TMC SPECIFICATION NO. S-222 A

TITLE: Modification of FFRD-7

To provide a modification procedure for Model FFRD-7 for greater HFO excursion.

D. PICTORIAL SCHEMATIC

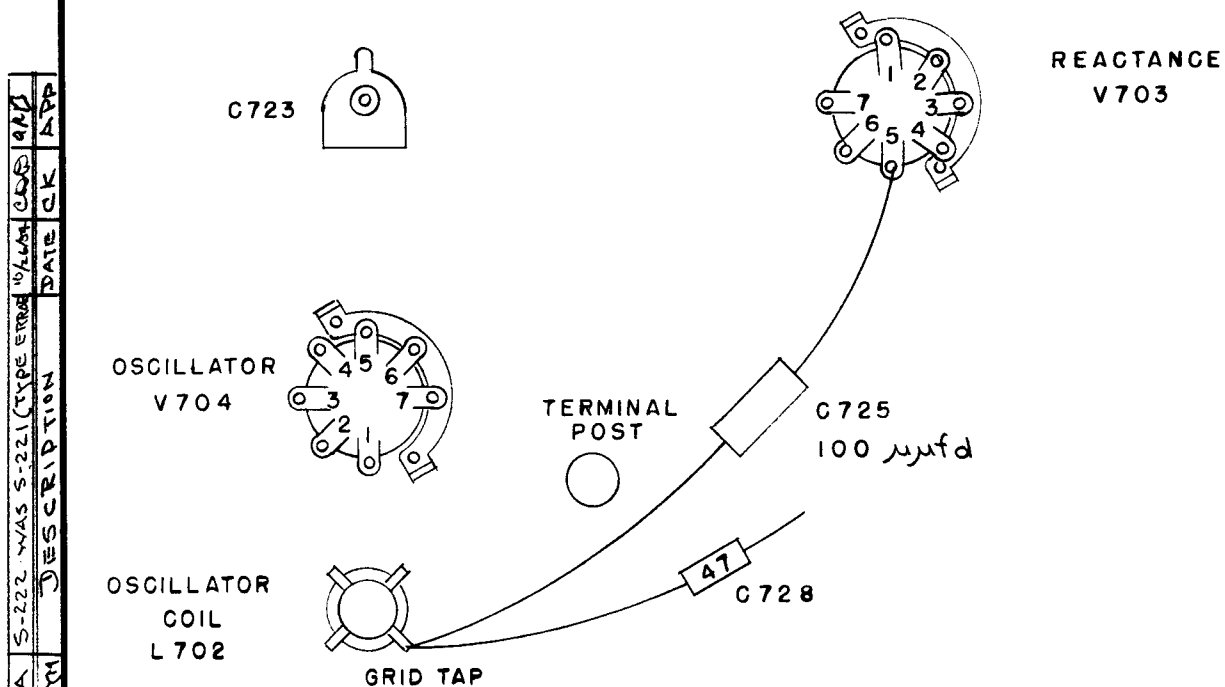
Remove capacitor C725, Part CC26SL101K, lead from the terminal post (see cut below) and re-connect it directly to the grid tap of the oscillator coil L-702. It may be necessary to increase the lead length to perform this operation.
